STATE OF WASHINGTON
DEPARTMENT OF ECOLOGY

January 31, 1994

Re: Sampling Plan to Identify the Potential Spill/Leak Near 242-A Evaporator
Discovered During Construction Excavation of the Pipeline for the 200
Area Treated Effluent Discharge Facility

Proposed Sampling Plan

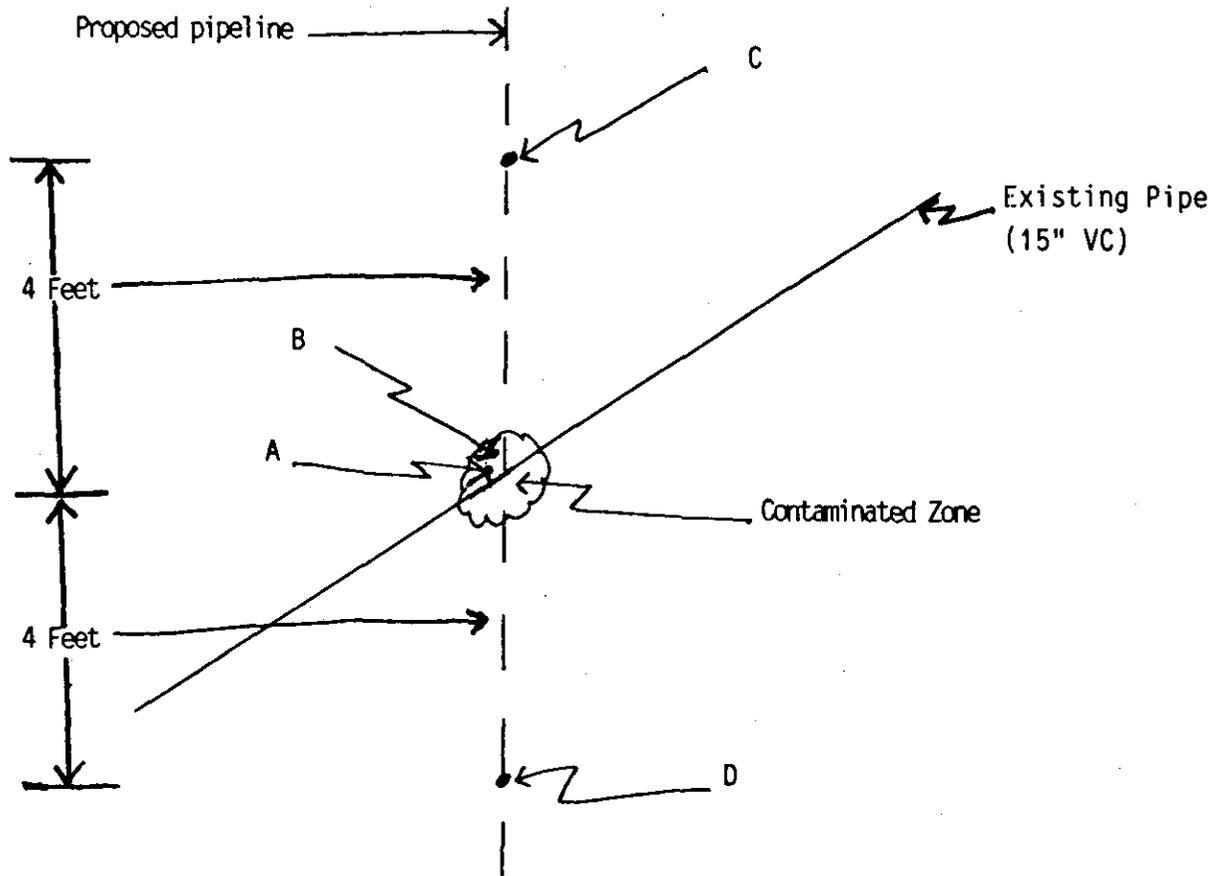
Samples 1 & 2: Two samples at the depth of three to three and a half feet at the existing pipeline location and within the zone of 'green soil' observed on December 13, 1993. Two samples are requested to provide duplicate analysis and minimize the eventuality of problems occurring with a single sample which contains the contaminated soil.

Sample 3: One sample at a depth of between eight to ten feet from the surface (assuming the pipe is at a level of four feet) and directly below the observed contamination.

Sample 4: One sample at a depth of six feet located four feet from the sampling site for the previous samples. This sample should be taken in the direction of the new pipe construction and not in the direction of the existing piping.

Sample 5: One sample at a depth of six feet located four feet from the sampling site for samples 1 & 2, but in the opposite direction from sample 4.

The attached figure is included for clarification. In addition, the depth of six feet for samples 4 & 5 is only meant as a goal. If contamination should be observed at a depth of less than six feet, a sample from this area would be appropriate.

A: Duplicate Samples 1 & 2 taken 3 - 3.5 feet below the surface and within the contamination zone*

B: Sample 3 taken 4 - 6 feet below existing pipe (8 - 10 feet below surface) and beneath contamination zone* or as near as possible to contamination zone without hitting the existing pipe

C: Sample 4 taken 4 feet from the contamination zone* and 6 feet below the surface

D: Sample 5 taken 4 feet from the contamination zone* and 6 feet below the surface

*Contamination Zone = Site of contamination (300,000 dpm green soil) observed on December 13, 1993
